PIC16(L)F15324/44 Family Silicon Errata and Data Sheet Clarification

The PIC16(L)F15324/44 family devices that you have received conform functionally to the current Device Data Sheet (DS40001889C), except for the anomalies described in this document.

Data Sheet Clarifications

2.1 Figure 37-5: Clock Timing

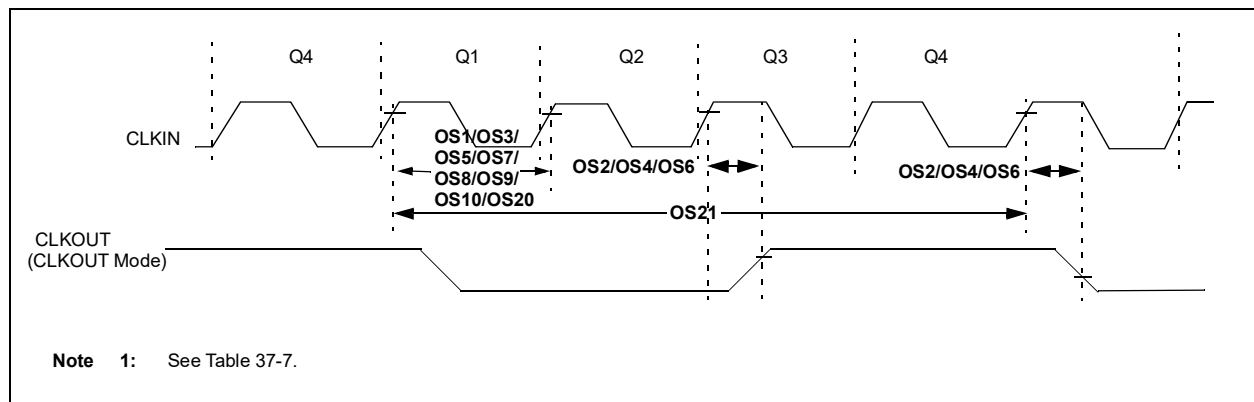
Figure 37-5 incorrectly shows the location of parameters OS1, OS2, OS3, OS4, OS5, OS6, OS7, OS8, OS9, OS10, OS20 and OS21. The correct location for the above-mentioned parameters is depicted in the following figure.

2.2 Figure 37-9: Brown-Out Reset Timing and Characteristics

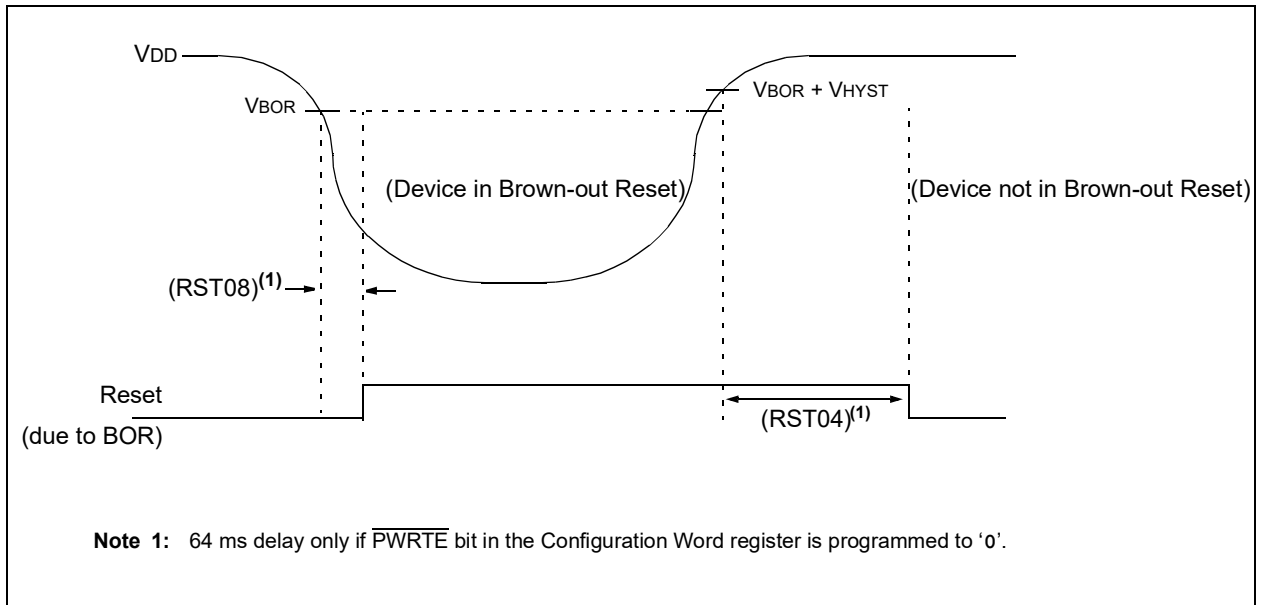
Note 1 in Figure 37-9 is incorrect. The correct note along with the figure is depicted below.
